RE: 7410 Washington St. NE
Grading and Drainage Plan
Engineer's Stamp Date: 01/11/19
Hydrology File: D17D003AA

Based upon the information provided in your submittal received 01/30/2019, the Grading Plan is **not** approved for Building Permit, Grading Permit and SO-19 Permit. The following comments need to be addressed for approval of the above referenced project:

DRAWING NAME: WALL LOW POND
SHEET
1 OF 3

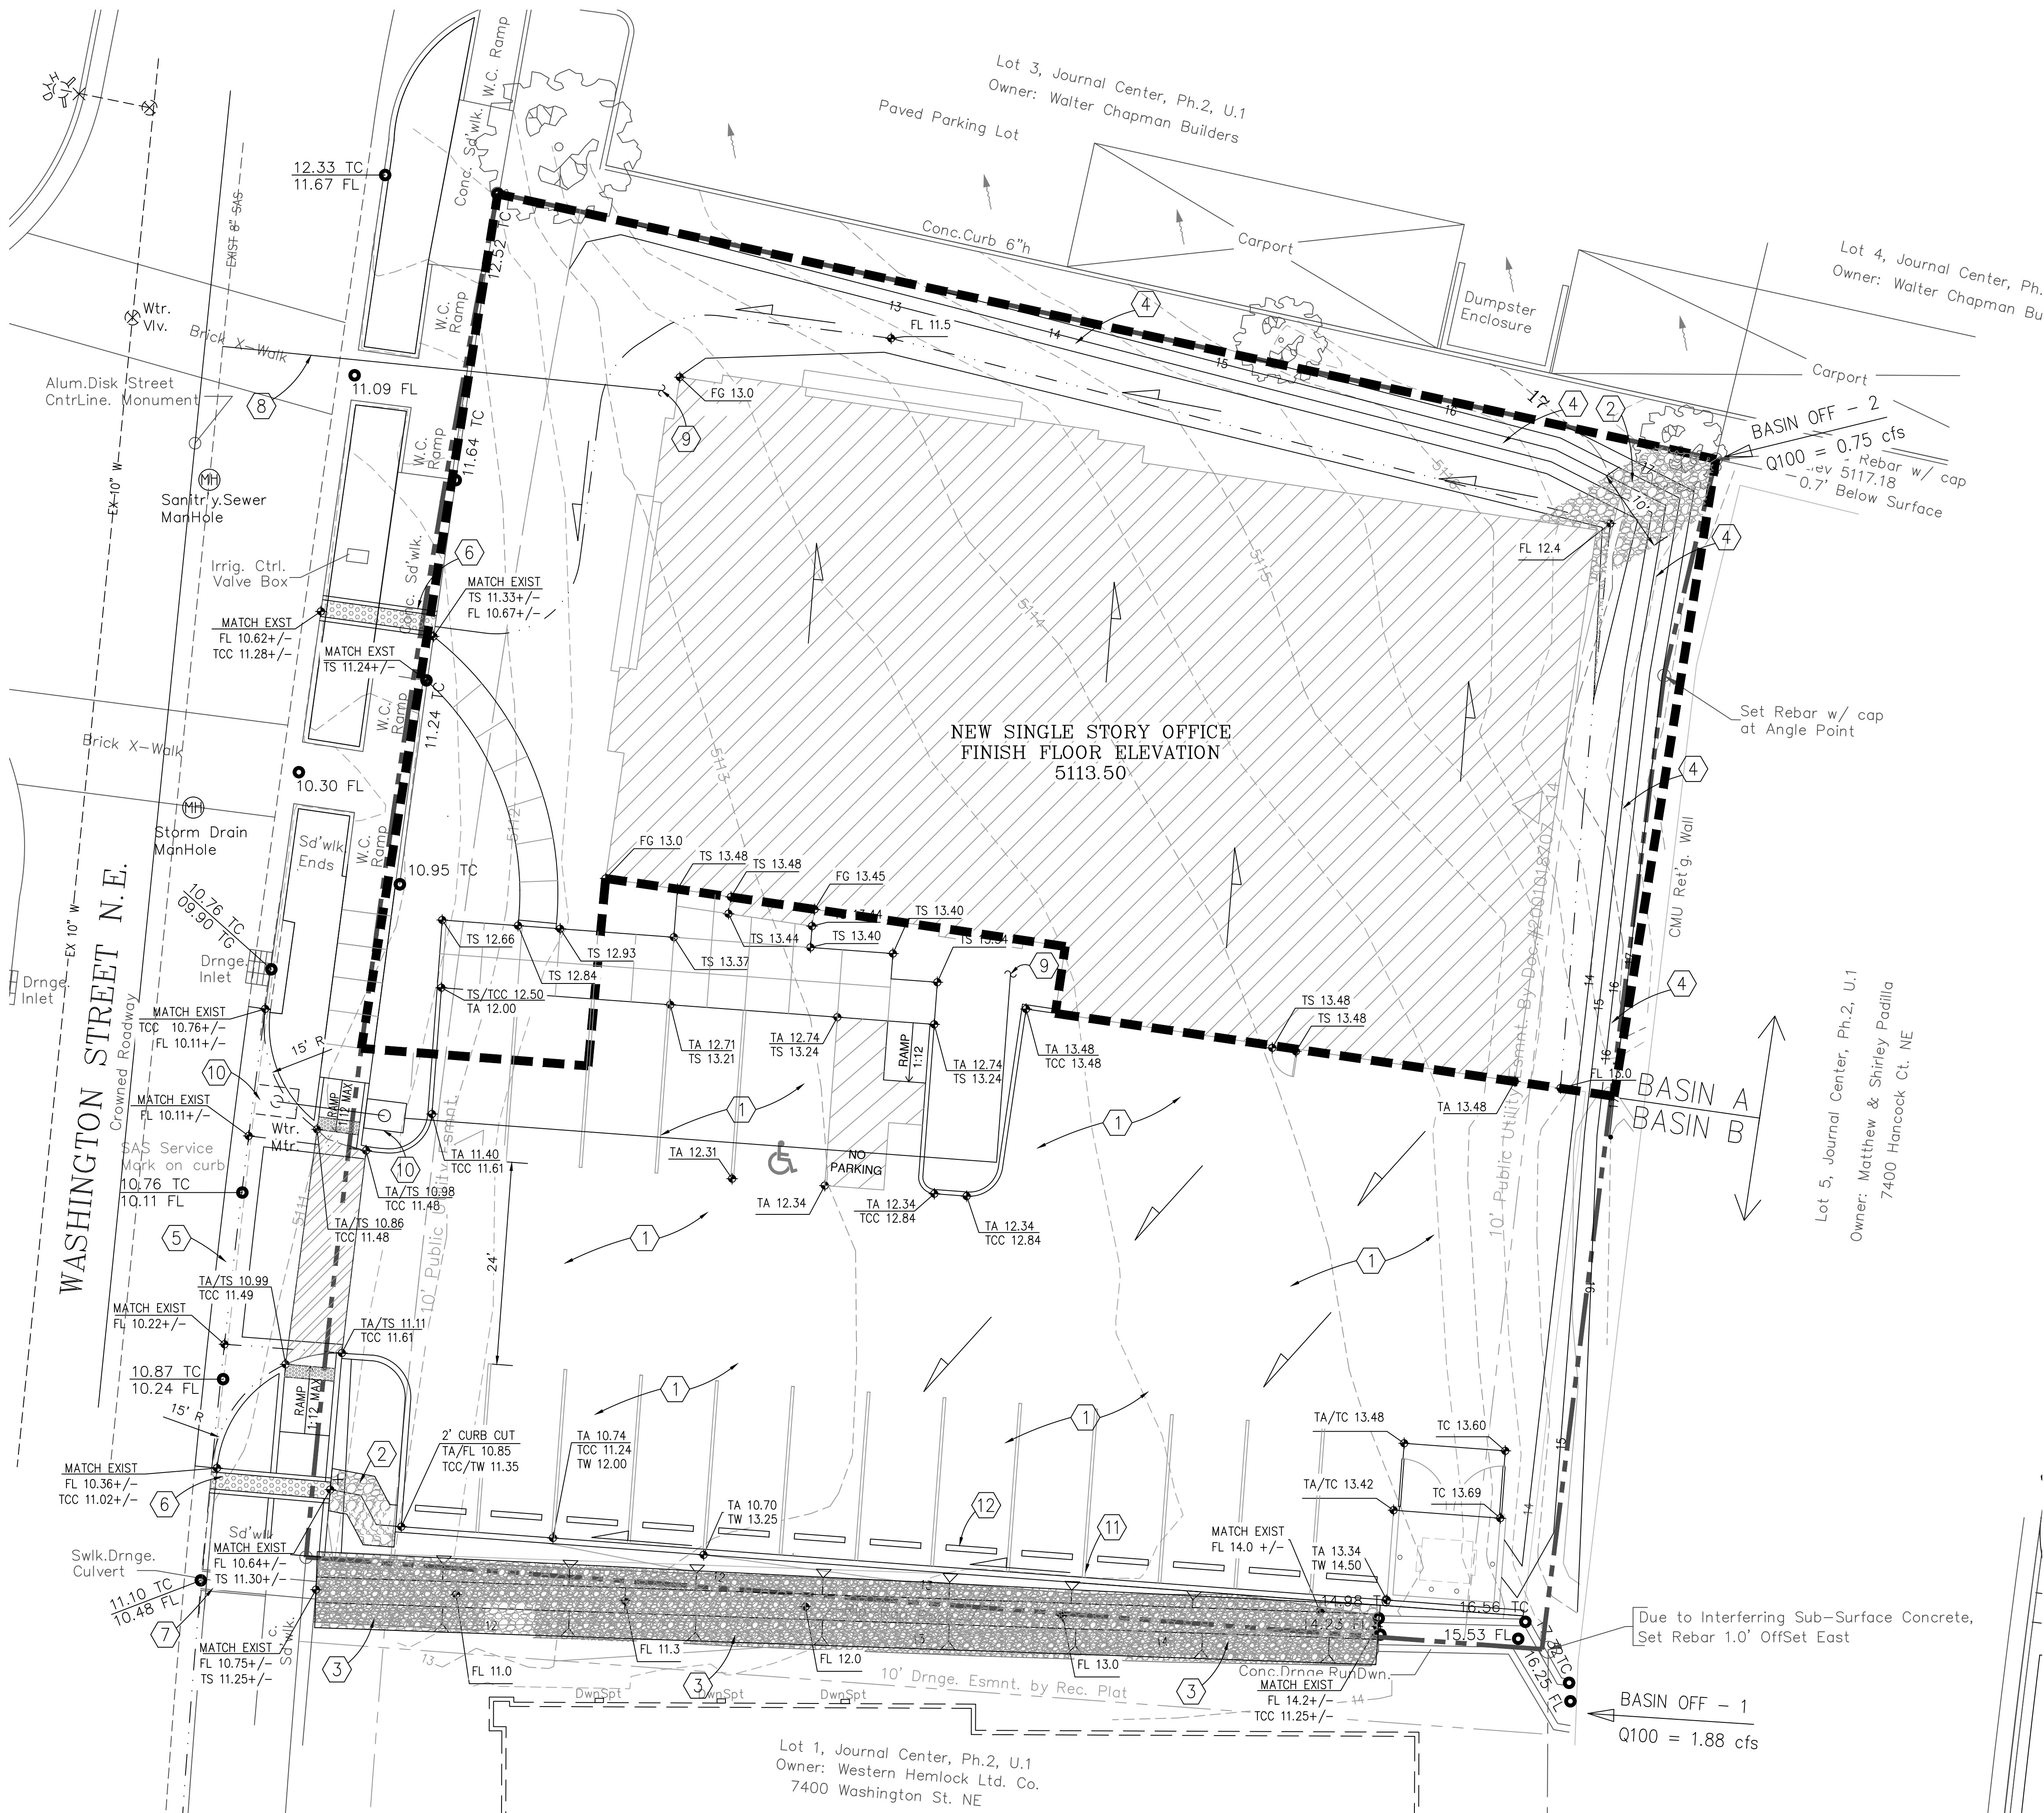
1. Please provide the benchmark information for the survey contour information provided.
2. Under Water Quality Ponding on Sheet 2, please add a note which states, "The Owner has elected to pay the Payment in Lieu for the required Stormwater Quality Volume of 463 CF. This payment Amount = 463 CF x \$8/CF = \$3,704.00."

4. Please provide a cross section of the riprap channel.
5. Please provide the calculations of the proposed riprap channel. This just needs to provide for the off-site flows of 1.88 cfs.

7. Please provide a section of the proposed swale.

8. Please provide calculations for the proposed swale. This needs to provide for the off-site flows of 0.75 cfs and on-site flows of 1.09 for a combined flow of 1.84 cfs.
9. Please add the SO-19 Notes on Sheet 1. See attached.
10. Standard review fee of \$150 will be required at the time of resubmittal.
